Addendum No.: 3

Date of Addendum: June 2, 2020

Willard Diloreto Parking Garage
Paul Manafort Sr. Drive
New Britain, CT
CF – RC – 402

The following clarifications are applicable to drawings and specifications for the project referenced above.

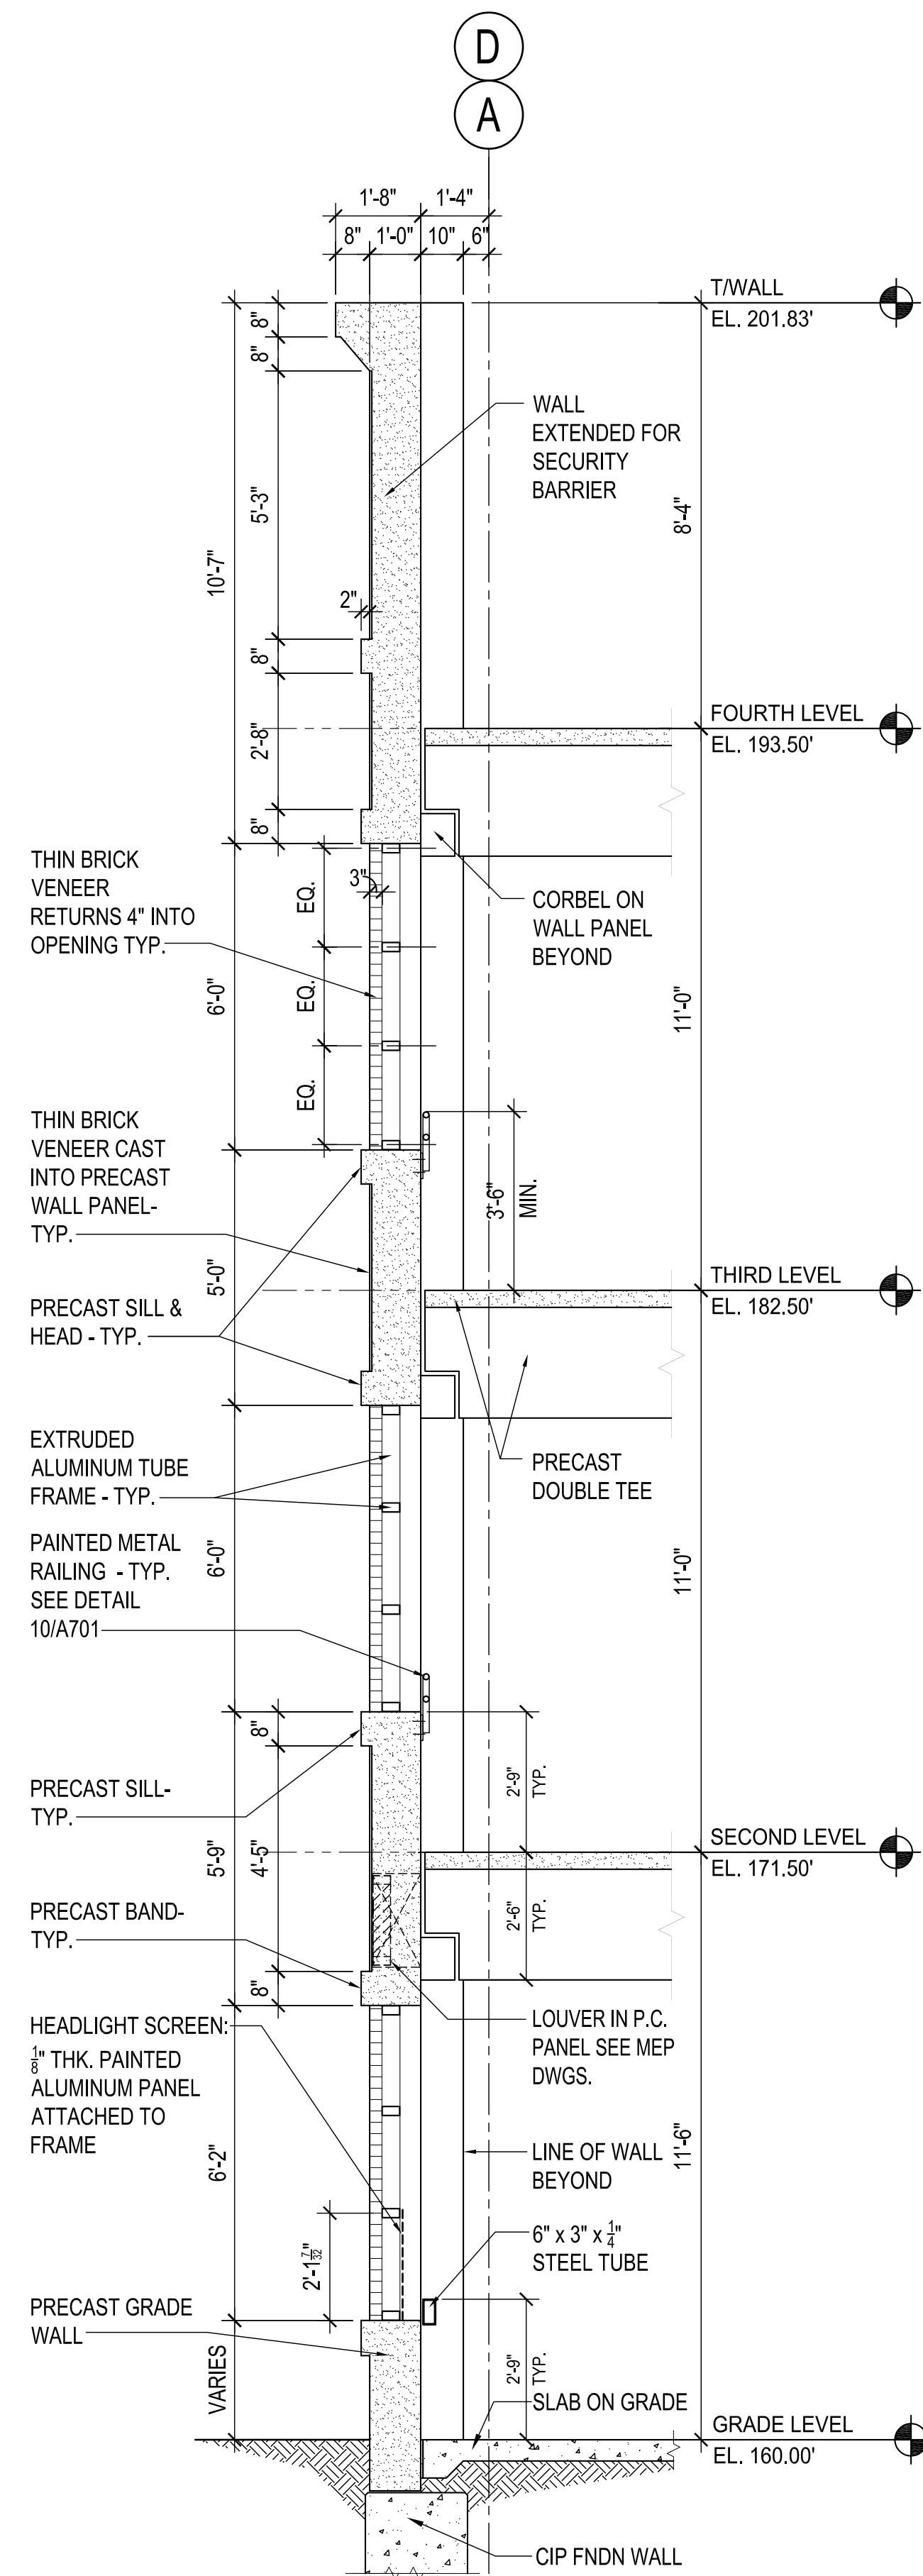
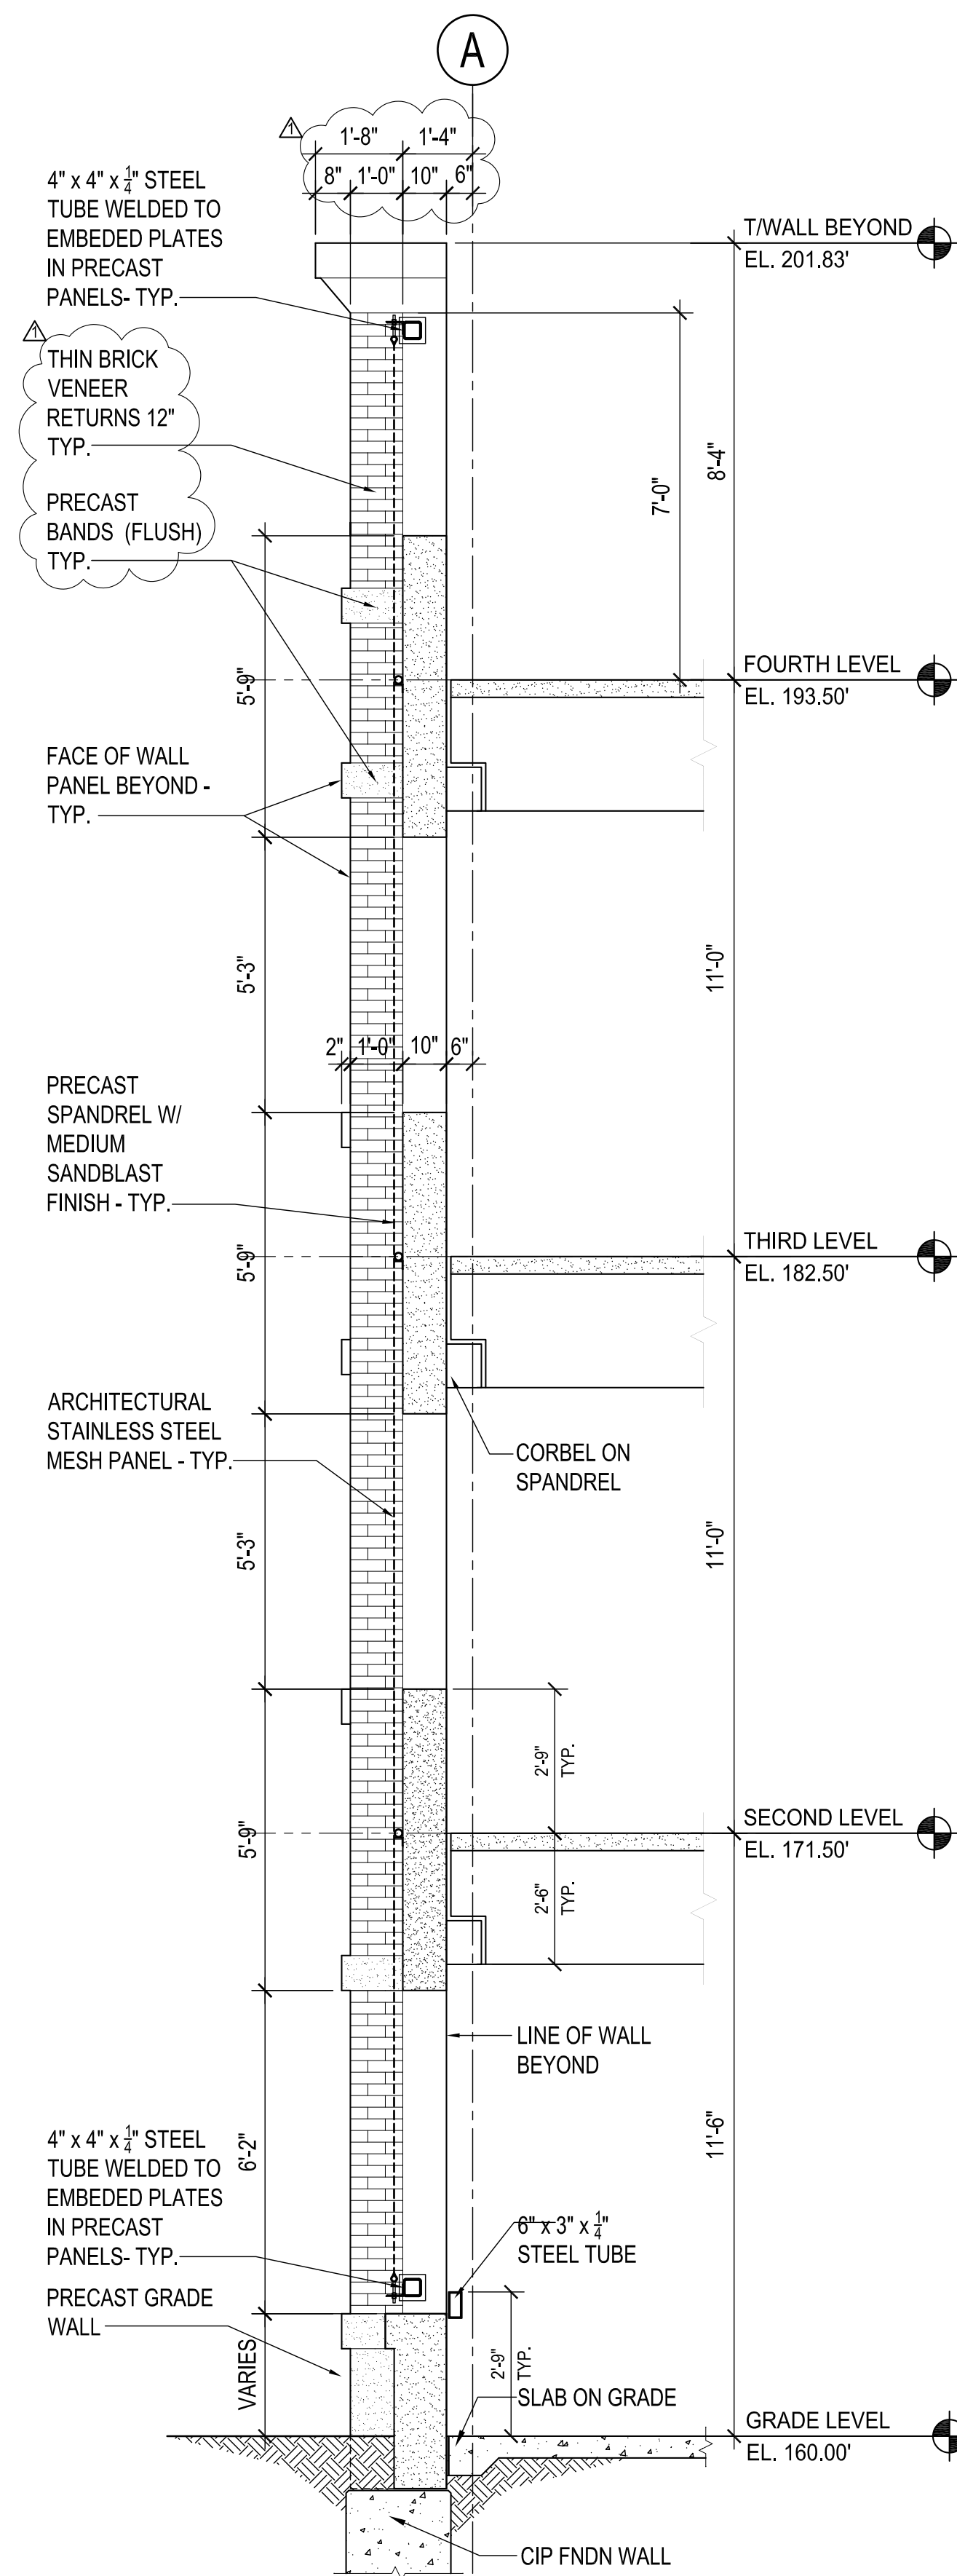
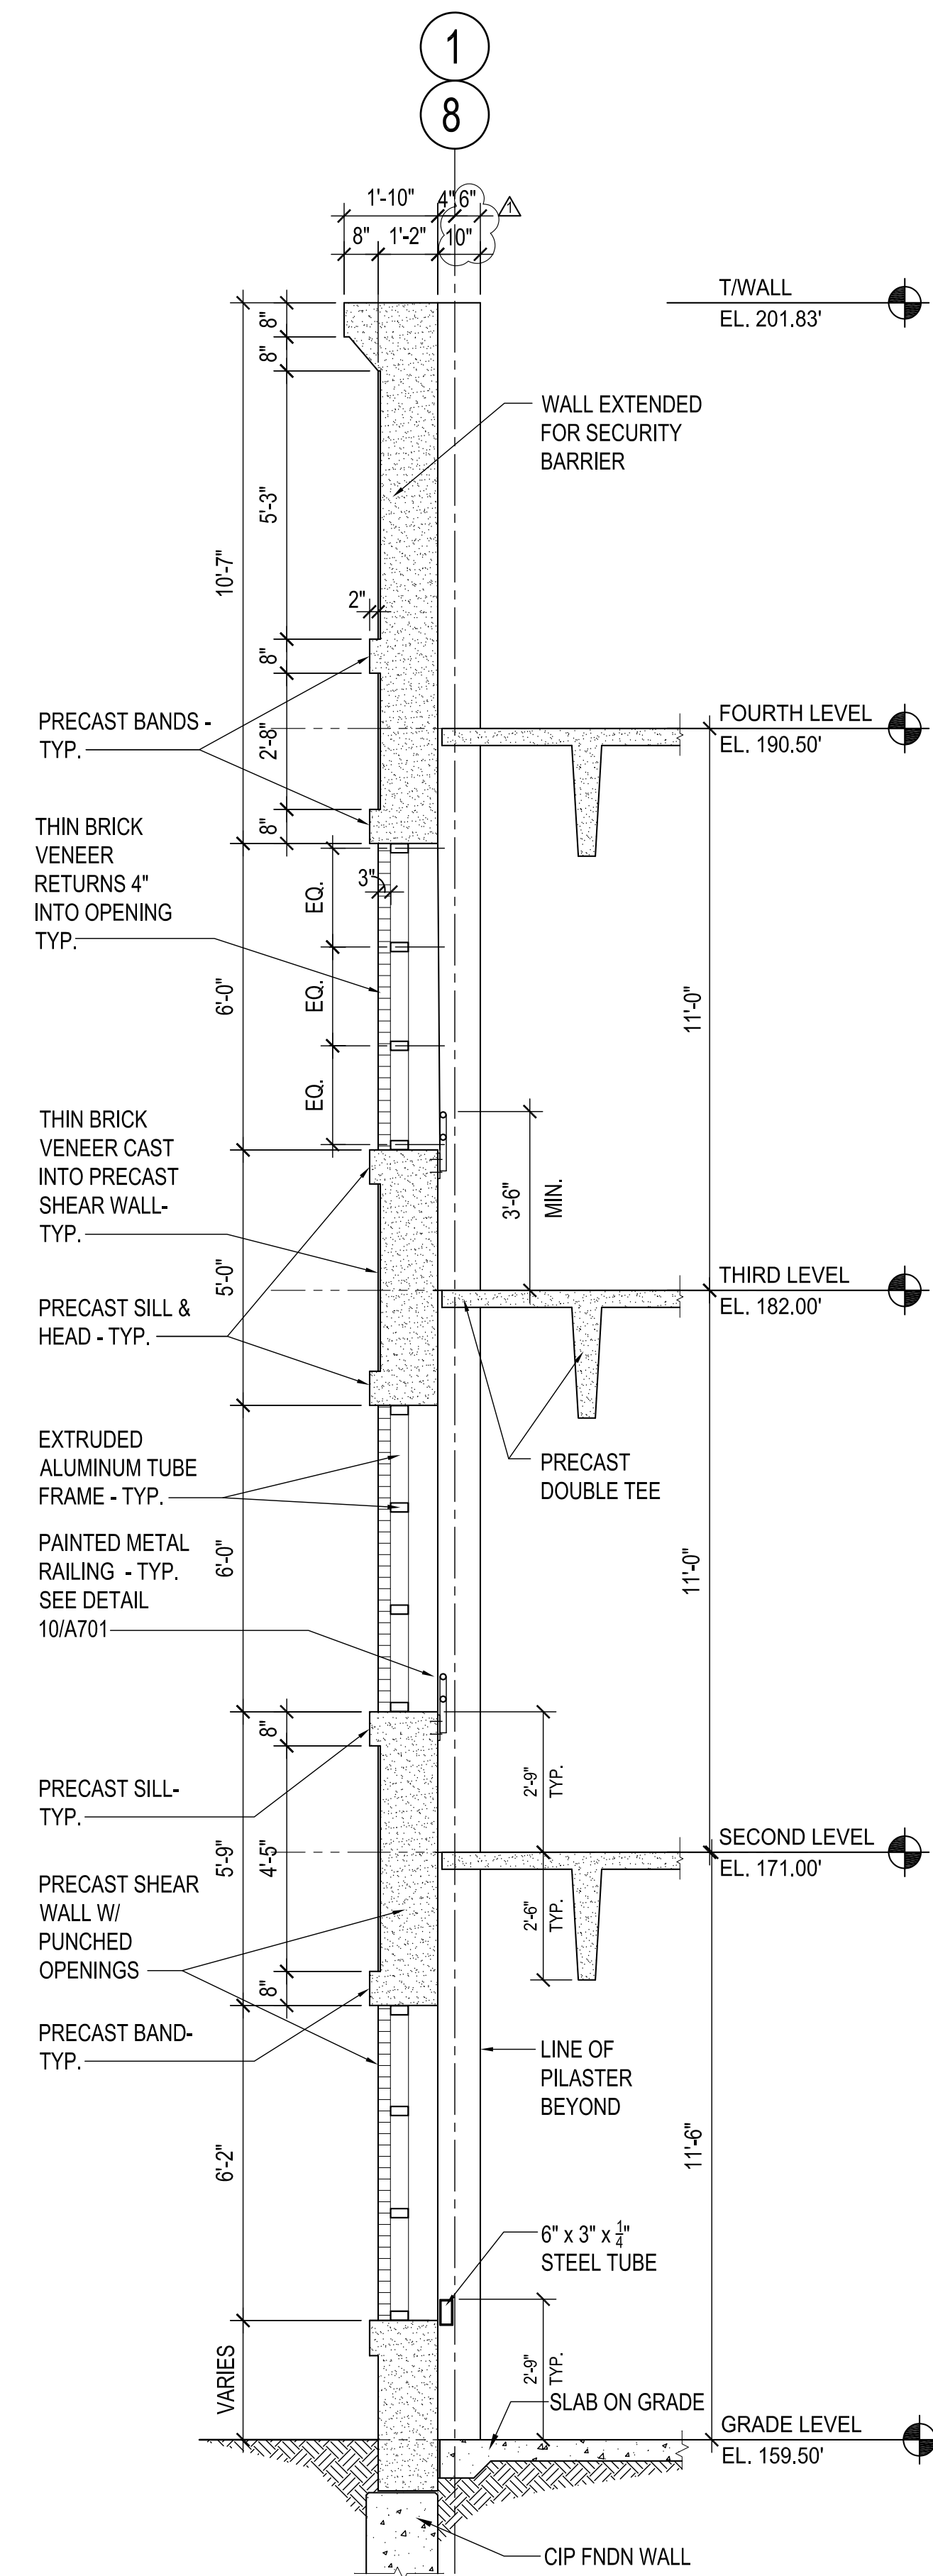
Question: Layout and Elevation Drawings- We do not find any drawings or details that clearly define the edge/end finish of the wall panels with the built-in-pilasters located along the North & South Elevations of the garage. The Elevations show a 'thin brick' finish on the exterior face of the wall panels, but the return portion (edge of panel with built-in-pilaster) is not clearly defined. Detail cuts '2', '3', & '4', from drawing A203, and Wall Section 2 on drawing A601, do not indicate a requirement for thin brick on return portion of the precast wall panels. Please provide a detail showing the finish for the return portion (edge/end of panel with built in-pilaster).

Question: Drawings A201 & A202- Please provide cornice detail at the top of the precast wall panels, centered on grid 2, shown on the North Elevation. Drawing appears to suggest full height vertical precast wall panels with a cornice at the top of the panel and section cuts shown on drawings A601 & A602 seem to indicate precast wall panels to be 12" thick. Based on full height vertical panels and a 12" thickness they become difficult to fabricate, handle and transport. Can the cornice at the top of the panel be a separate piece? Can the panel thickness be reduced to 8" thick? Can a stack of horizontal wall panels be provided in lieu of full height vertical panels?

Question: Drawing A601- Wall Section 3 indicates the shearwalls along grids '1' & '8', as being 1'-2" thick whereas structural drawing S105 indicate shearwalls as 12" thick with 12" thick pilaster. Please advise if the thickness of the shearwalls is to be determined by the precast design engineer or provide the thickness required.

Answer: See revised drawings A203, A402, A407, A409, A601 and A602 showing extents of thin brick and thin brick returns at openings.

Answer: See revised drawings A601 and A602 indicating cornice dimensions.

Answer: The thickness of the shear walls and the inclusion of a pilaster or corbel for the inverted tee girders are to be determined by the precast design engineer. The exterior face and width of the shear walls are to be as per the Drawings.
